Subject: **BSPP RESPONSE TO ALUC COMMENTS OF MARCH 22, 2010 ON ALUC APPLICATION AND SUBSEQUENT CORRESPONDENCE BY EMAIL ON APRIL 13, 2010**
BSPP RESPONSE TO ALUC COMMISSION COMMENTS FROM MAY 13, 2010 COMMISSION MEETING
DOCKET NO. (09-AFC-6)

**BLYTHE SOLAR POWER PROJECT (09-AFC-6)
RESPONSE TO ALUC COMMENTS OF MARCH 22, 2010
ON ALUC APPLICATION AND SUBSEQUENT CORRESPONDENCE
BY EMAIL ON APRIL 13, 2010**

Response Date: May 4, 2010

Figure 1. Location of ACC-4 Outside of the Blythe Airport Influence Area.

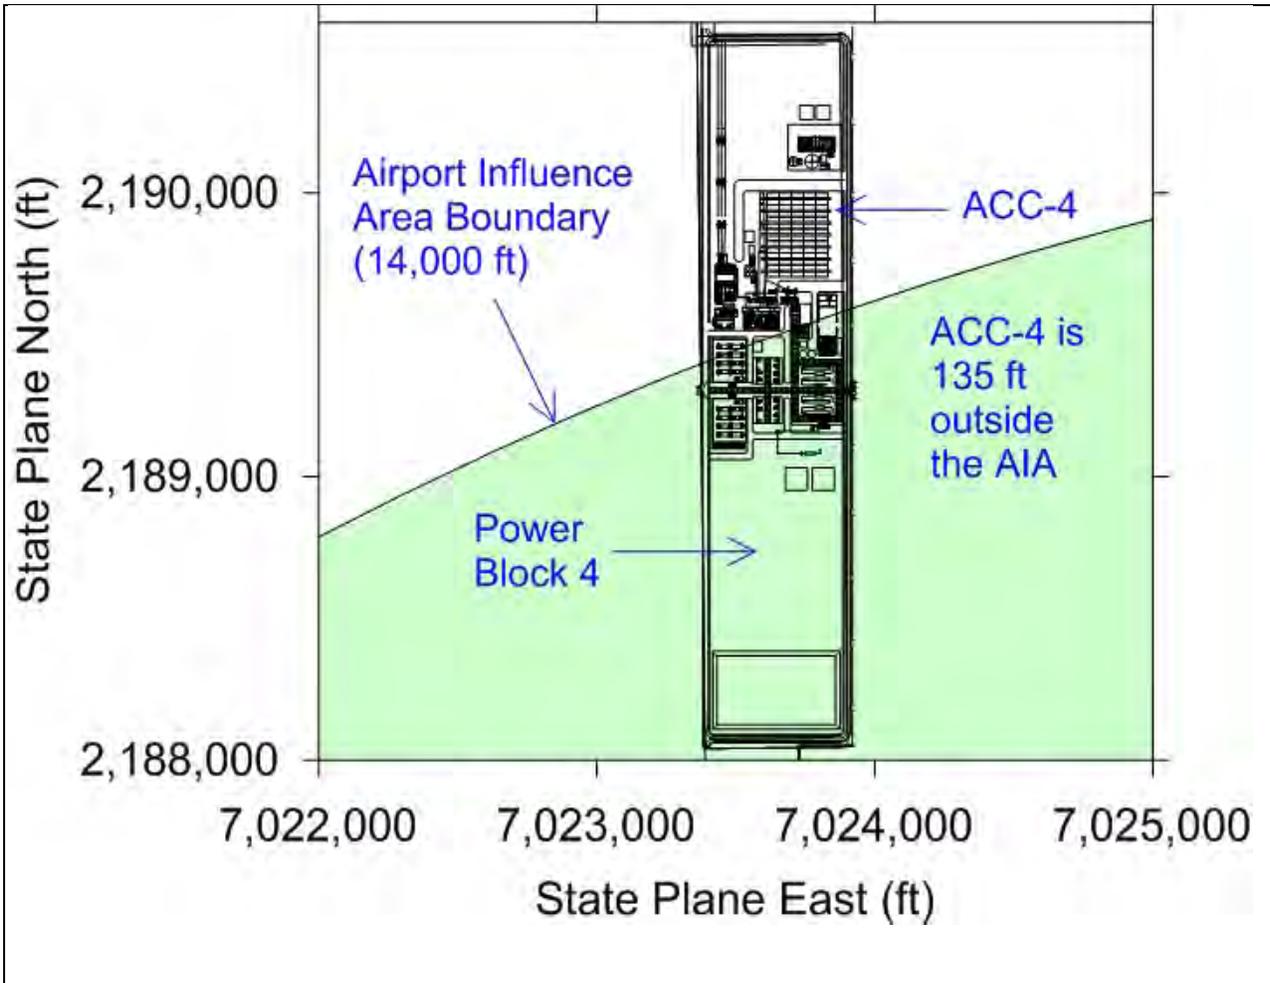
Confirm by map/figure that ACC-4 is located outside of the AIA boundaries. If it is within the AIA, then it is inconsistent with maximum height requirements.

The southeastern corner of the Air Cooled Condenser 4 (ACC-4) is approximately 135 feet outside of the boundary of the Airport Influence Area. Figure 1 presents a graphic showing Power Block 4, the location of ACC-4, and the 14,000 ft limit of the AIA. The Applicant commits that the ACC-4 and auxiliary cooling tower will remain outside the Airport Influence Area in the final project plan.

Figure 2. Map Showing the Original Locations of Power Poles within the Airport Influence Area and the Compatibility Zones Filed with FAA in November 2009.

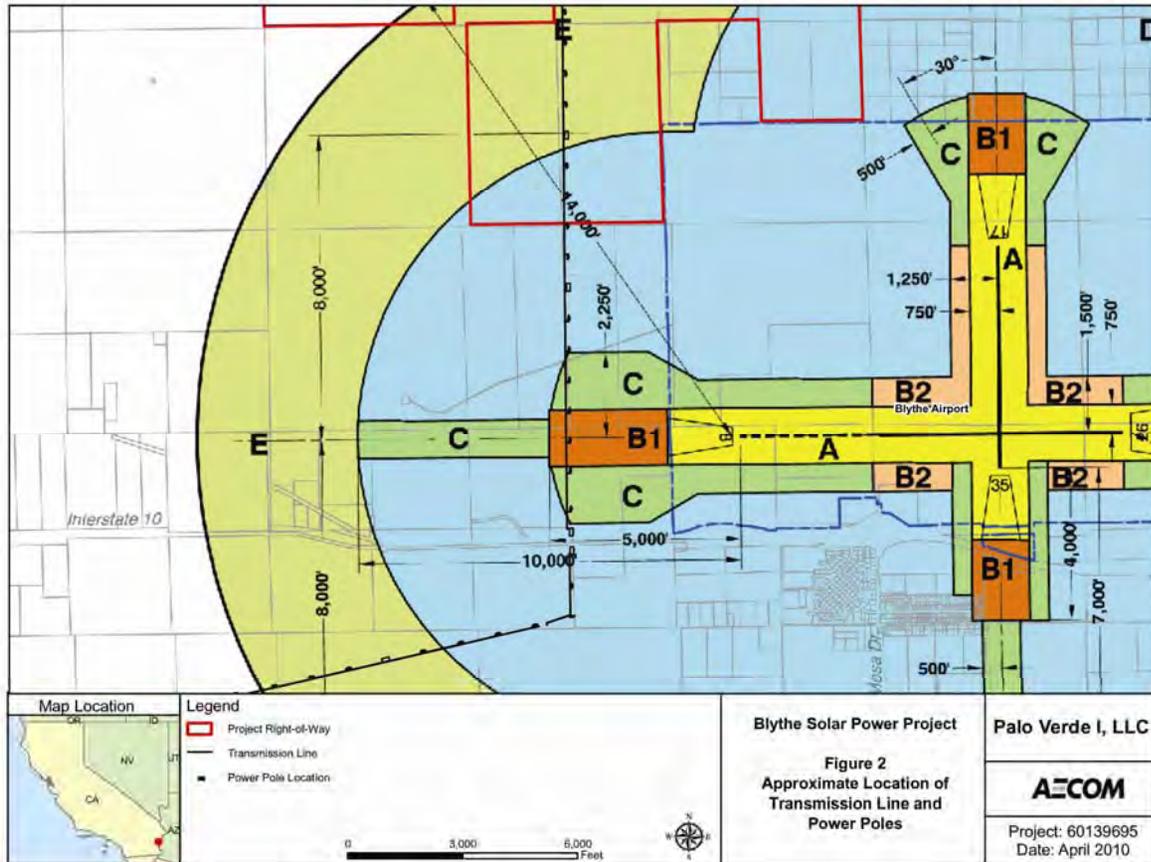
Identify the height and number of proposed transmission poles relative to AIA Zones.

See Table 1 for a listing of each pole, their height, and the Compatibility Zone in which each is located. Figure 2 provides a map of the locations of the power poles in the separate Compatibility Zones for the Blythe Airport. Based on ALUC comments, the Applicant is modifying the Gen-Tie line route to avoid crossing Compatibility Zone B1 and commits that the new route will both avoid Zone B1 and will have transmission poles no higher than 70 ft for that portion of the revised route that crosses Zone C. Graphics of the proposed route are not available but the Applicant commits to have submitted all new FAA notifications by the May 13 Commission Meeting and will have information on specific pole locations available at that time.

Figure 3. Map Showing the Status of FAA Form 7460 Applications to the FAA.

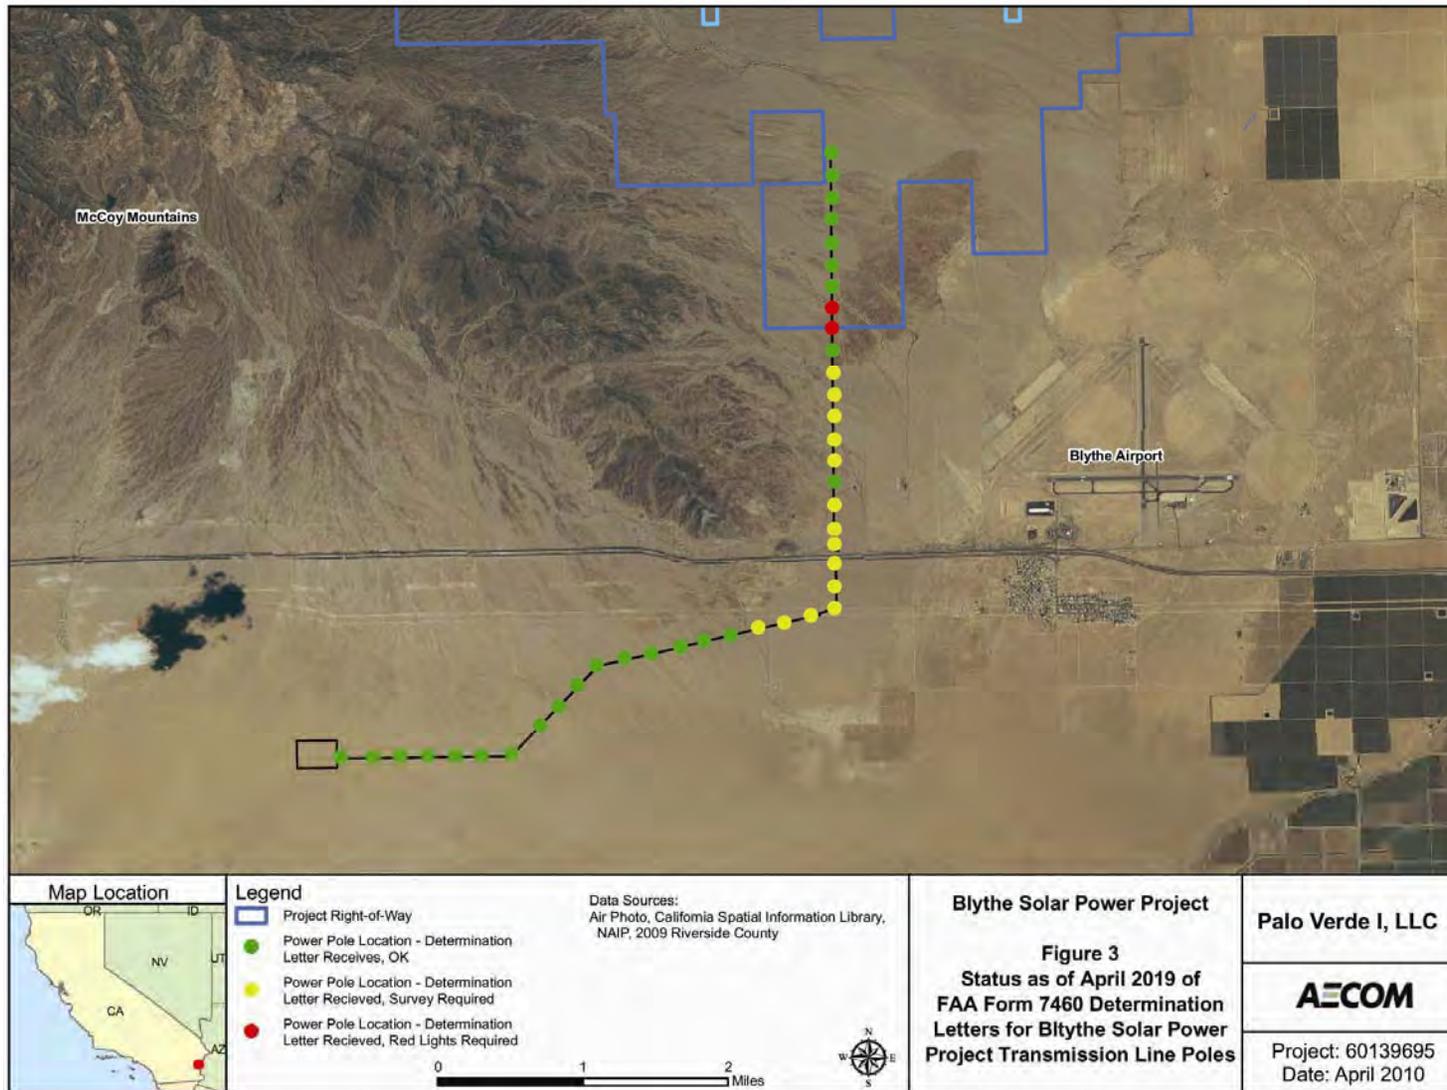
Update on FAA review of remaining transmission poles.

See Table 1 for a listing of each pole and its current FAA status as of 04/19/2010. Figure 3 presents a color coded map illustrating the status of each transmission line pole for which an FAA Form 7460 application has been submitted. AECOM contacted Ms. Karen McDonald of the FAA on April 14 to enquire as to the status of their review. Ms. McDonald stated that all seven review departments have finished their analyses and she is now compiling the review comments prior to issuing a determination. She cannot commit to a completion date for her review and issuance of the determinations. She did say that regulations may dictate that some of the cases will require public notice prior to final determination.

Figure 7 Elevation Profiles West of Extended Runway 26 Centerline

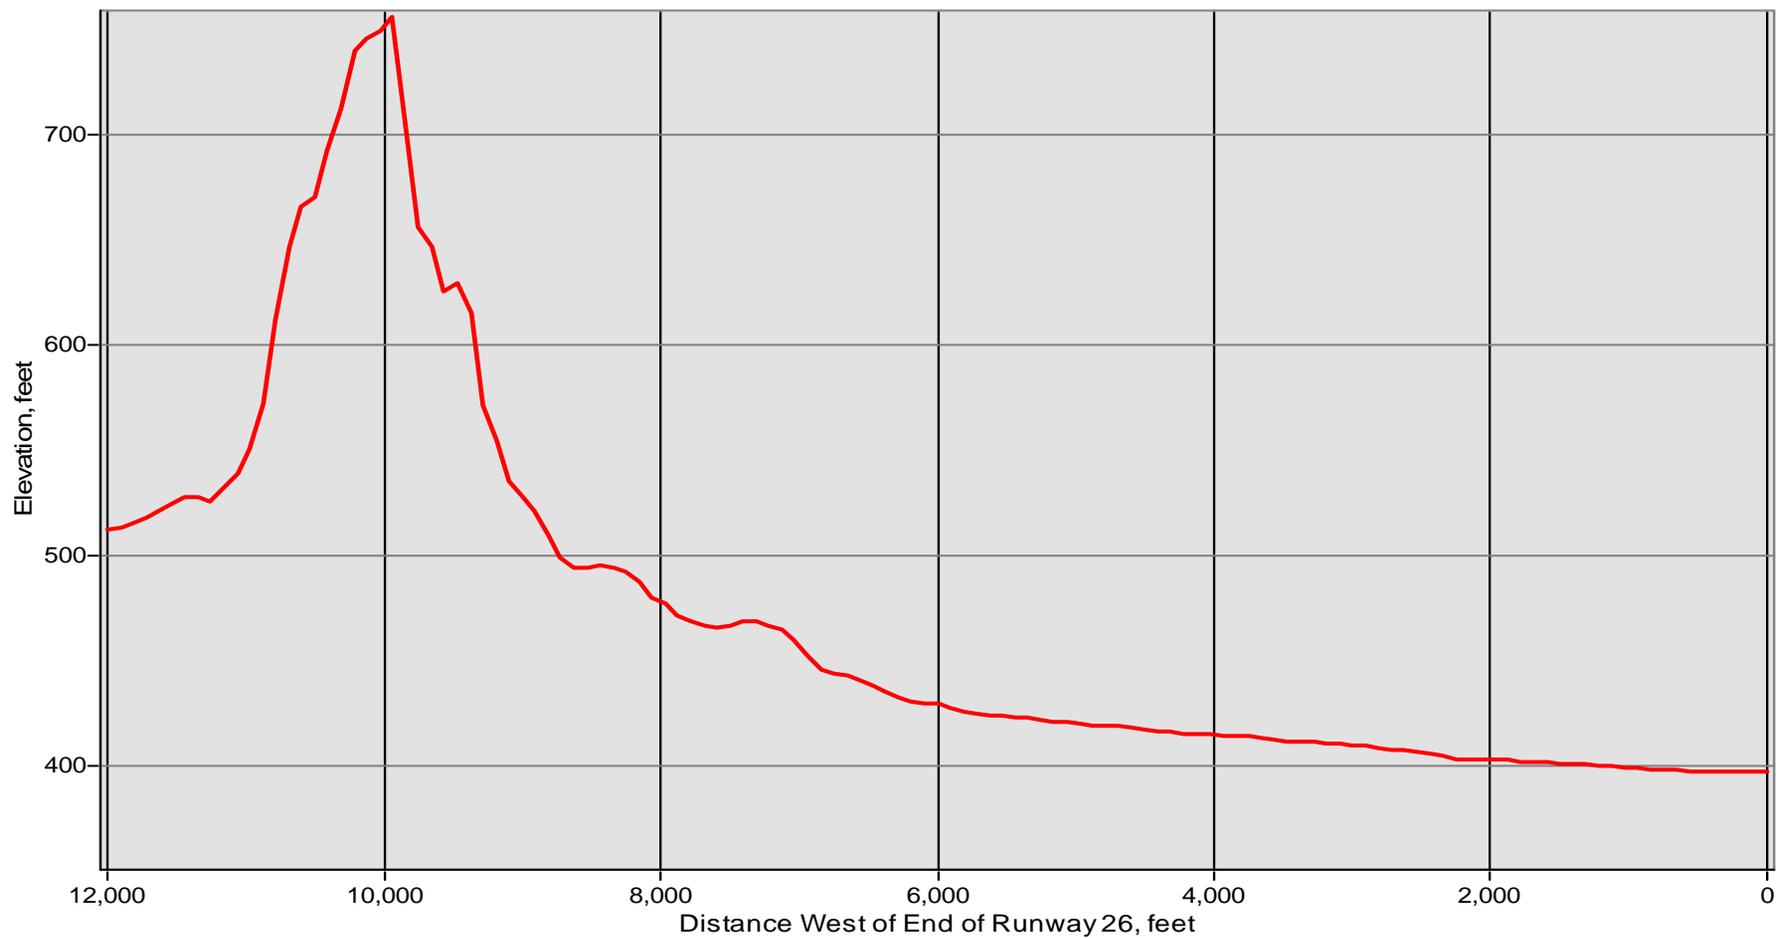
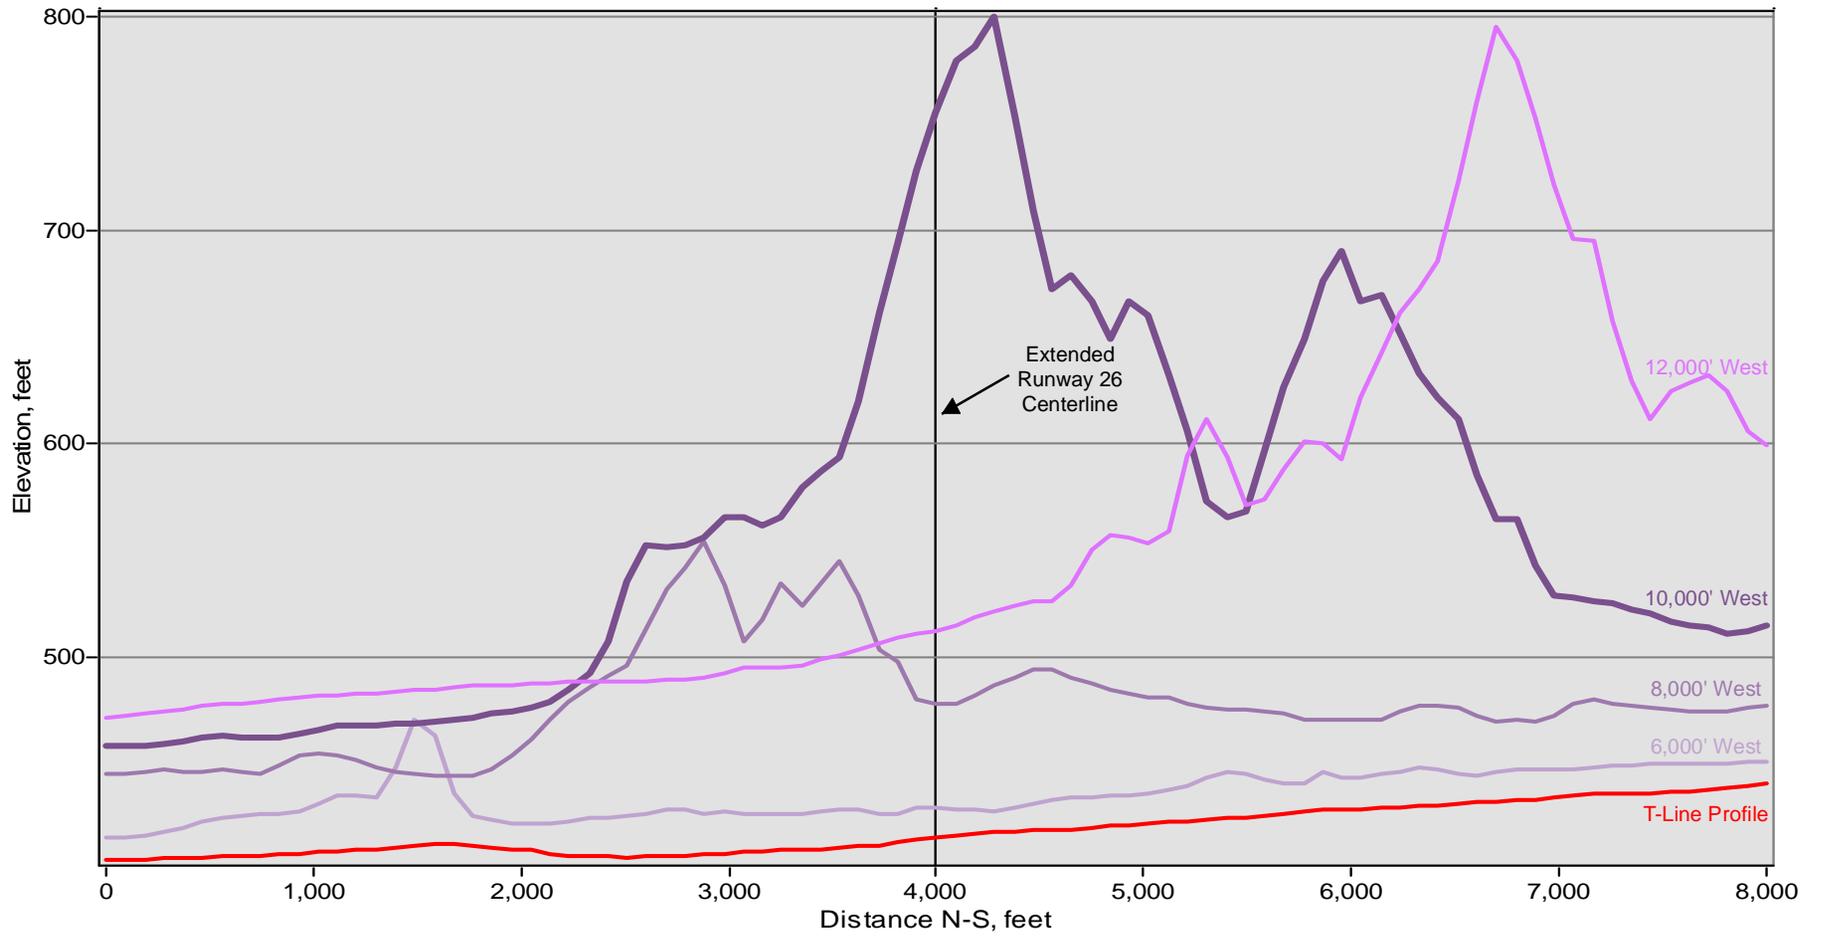
At the April 8 meeting, the Commission Chairman advised that he would not be inclined to support aboveground transmission lines crossing through Zones B1 and C directly westerly of the east-west runway at Blythe Airport, especially since the approach from the east is already constrained by aboveground lines just east of the Zone A boundary.

Figure 7 presents a series of north-south elevation profiles spaced approximately 2,000 feet apart west of the end of Runway 26. Each successive profile west is higher than the preceding profile. Only at the 12,000 profile does the terrain fall on the far side of the McCoy Mountains. Figure 8 presents a map showing the locations of the east-west profile and the north-south profiles. The Transmission line would have to be located to the west of the McCoy Mountains for it to not pass over zone C. However, the routing for such a transmission corridor would be problematic since it would have to cross over the McCoy Mountains to allow the poles to the west of the runway to be on the far side of the mountain.

Figure 9. Location of the Palmdale Hybrid Power Plant with respect to Air Force Plant 42

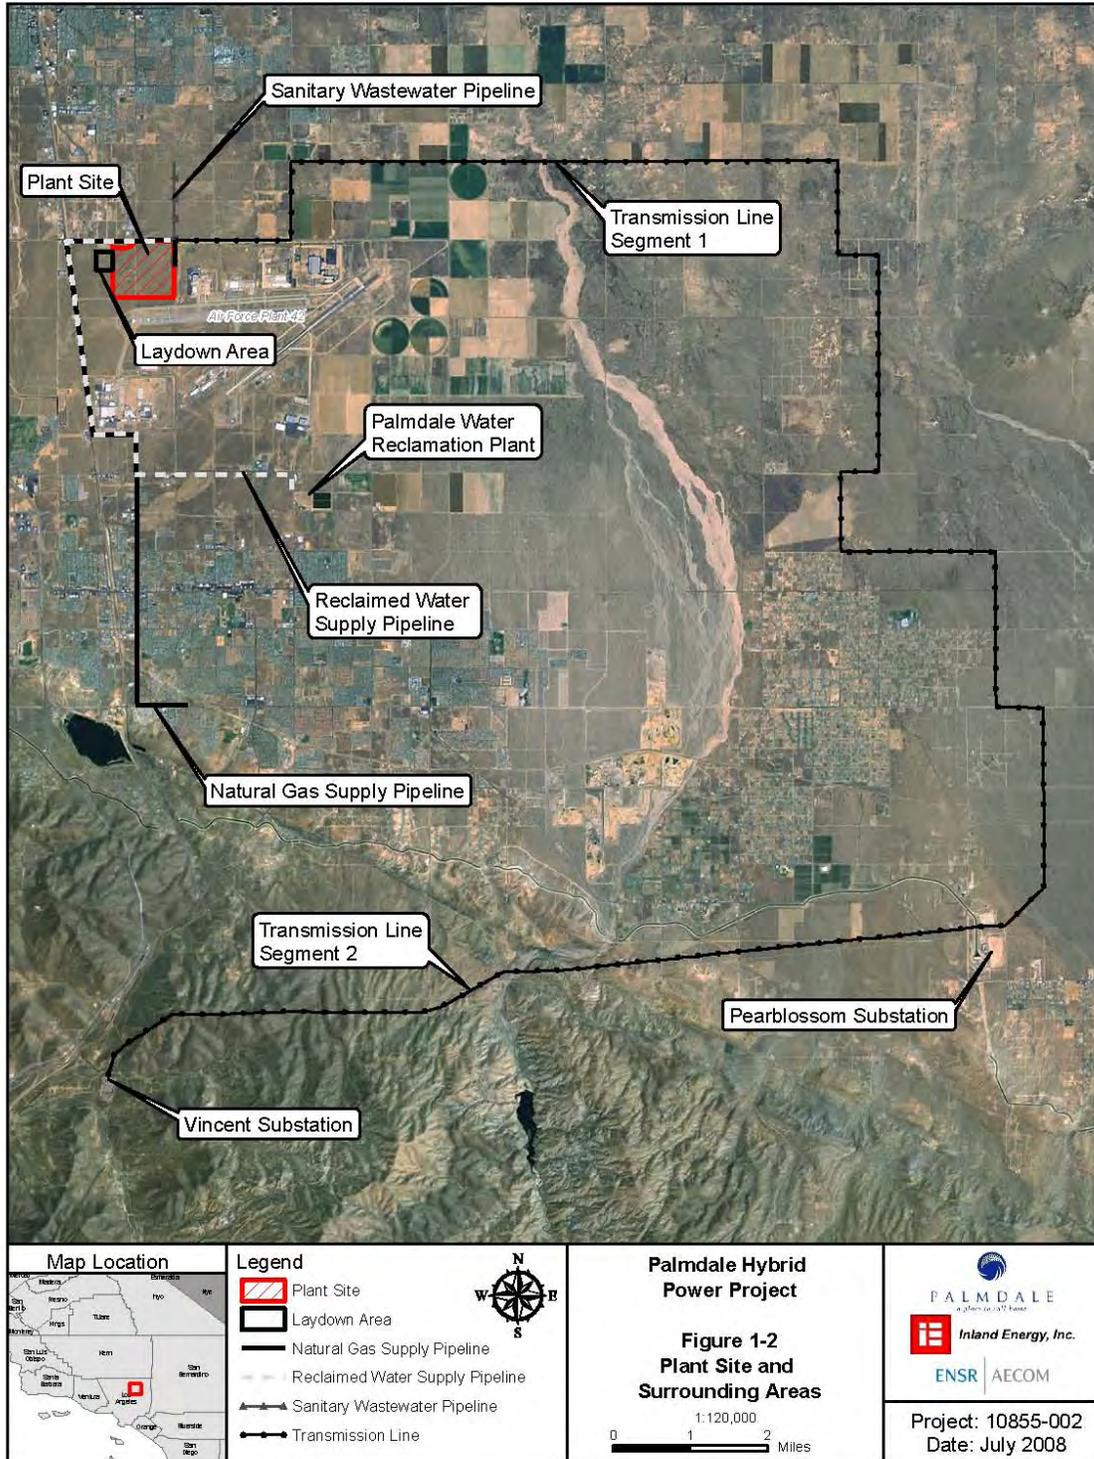
Detail how BSPP is comparable to the Palmdale Hybrid Power Project (PHPP) (i.e. total project acres, total MW, location related to distance from airport and to flight paths)

The Palmdale Hybrid Power Project (PHPP) is located immediately adjacent to the north side of the departure end of Runway 25 at the Palmdale Regional Airport/Air Force Plant 42. The PHPP plant site shares a boundary with Plant 42. The PHPP is located on a 337 acre site and is composed of two natural gas fired combustion turbine generators (CTGs), two heat recovery steam generators (HRSGs), and one steam turbine generator (STG), and a 250 acre solar thermal mirror array with parabolic trough mirrors. The power rating of the solar thermal mirror array is a nominal 50 MW. The overall power rating of the PHPP is 570 MW. Figure 9 presents a map showing the location of the PHPP project and Plant 42. At a nominal 1,000 MW, the BSPP is considerably larger than the solar field for the PHPP, but the BSPP mirrors are much farther away from the Blythe Airport and its traffic patterns (approximately 8,200 ft from Runway 35) compared to the distance from the PHPP project to the Plant 42 runways and traffic patterns (approximately 1,500 ft from Runway 25).
